RE: Application for ORTEL CORPORATION
 CDMA Channel Selective Repeater, Models CDR 1901 and CDR 1912
FCC ID: LB41900CDMA

Product: Ortel Channel Selective CDMA Repeaters
Re: CDR Test Data Submitted to the FCC
FCC ID: LB41900CDMA

REPORT NO. S8310 FCCI ID: LB41900CDMA

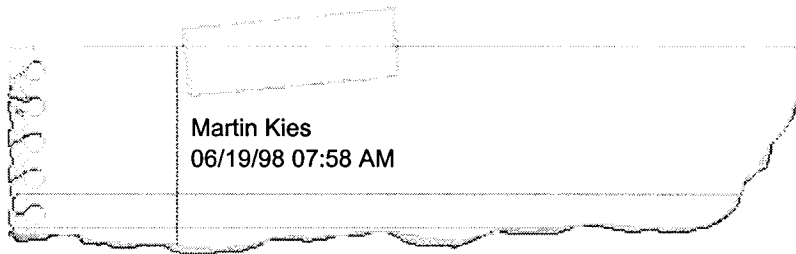
Greg: Here is some information to supplement my voicemail on 4/14. We are approved for the following on the CDR repeater (FCC ID: LB41901CDMA):

Planned versions are as follows:

All amps are exactly the same electrically, they are only biased differently. Version b) would add a splitter, combiner, and 2 additional Ch to the repeater box. Does one version (a or b) approve the other? Can we test to one to "cover" the other?

This is in response to your e-mail, copied below, and the subsequent fax you sent me (re-sent yesterday). The 1 ch. 4W repeater and the 2 ch. 2W/ch. repeaters (labelled a) and b) in the fax) may be authorized under one FCC ID, a different FC ID than the previously authorized 1 ch. 2W device. Run a complete set of tests on the 1 ch. 4W repeater, and in addition, run a 2 tone intermod test on the 2 ch. version.
